# **N-series Intel<sup>®</sup> Pentium<sup>®</sup> Processors and Intel<sup>®</sup> Celeron<sup>®</sup> Processors**

**Specification Update**

*December 2018*

*Revision 016*

### RCOMP Value Register

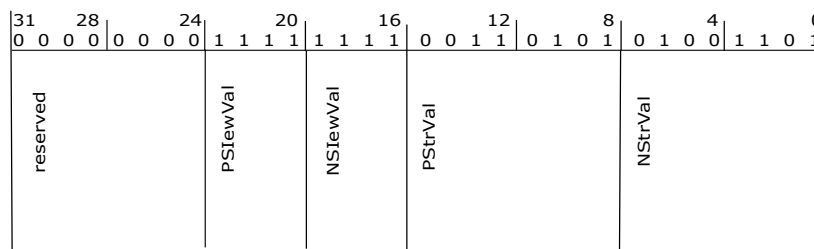
This section provides additional notes to describe the bit range of PSlewVal and NSlewVal in Section 33.7.66 RCOMP Value Register (hshvfamily\_3x3\_rcomp\_9\_0\_family\_rcomp\_value\_reg) - **Offset 120Ch**

#### GPIO Family RCOMP Register

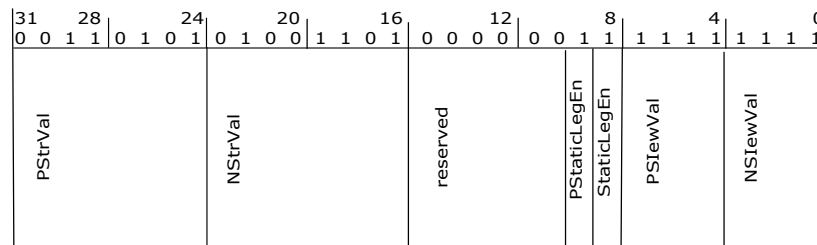
This section provides additional notes to describe the bit range of PSlewVal and NSlewVal in section 33.7.66 Family\_config\_rcomp\_reg (hshvfamily\_3x3\_rcomp\_9\_0\_family\_rcomp\_value\_reg) - **Offset 1210h**
